NSLPP MEETING HELD ON 01/06/2022

ADDRESS/WARD: 107 High Street, North Sydney

APPLICATION No: DA 281/21

PROPOSAL: Demolition of an existing residential flat building and construction of a

Figure 15: Floor plan of No. 10 Bradly Avenue Source: Walsh Analysis

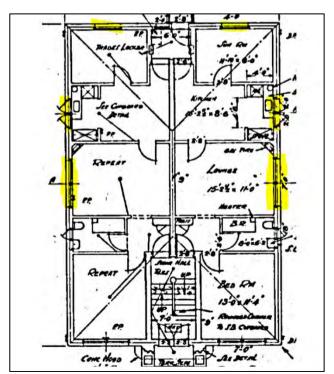
The applicant's solar analysis includes internal floor plans of these units. The diagrams show that No. 6 Bradly Avenue has bedrooms at the northern elevation whilst No. 8 Bradly Avenue has kitchens at the northern elevation and No. 10 Bradly Avenue includes sunrooms or secondary living space – refer to **Figure 15.**

In addition, No. 8 has the benefit of additional windows within the eastern and western elevations affording additional solar access to these spaces. No. 10 primary living spaces are more centrally located within the unit allowing for windows within the eastern and western elevations.

Accordingly, the primary living area of all units remain unaffected by the proposed development, as these spaces receives sunlight from alternative windows.

FIGURE 1 UPDATED AMENDED DA SET RESOURCE MAYOH ARCHITECTS 2021

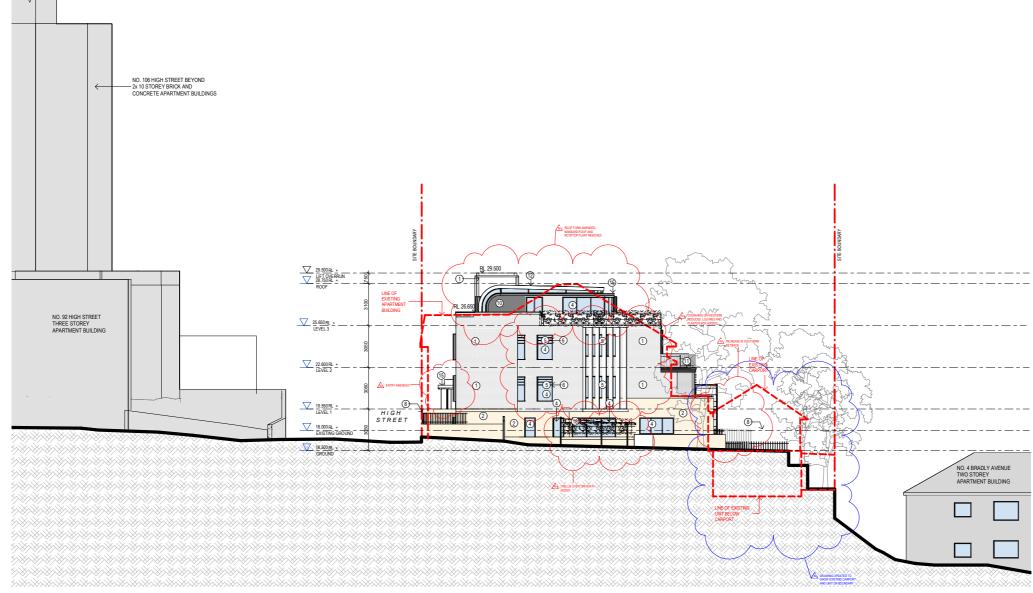
DA set drawing 150 rev N, shows the north and south elevations proposed and that the centrally located lift and over run will create a minor visible projection above the flat roof, which sits within the permissible height controls.

In summary the height, width and scale is similar to the existing building on the site and is fully compliant with relevant building envelope controls which affect potential view loss including the applicable LEP Building Height, DCP Building Height Plane and floor space ratio (FSR).
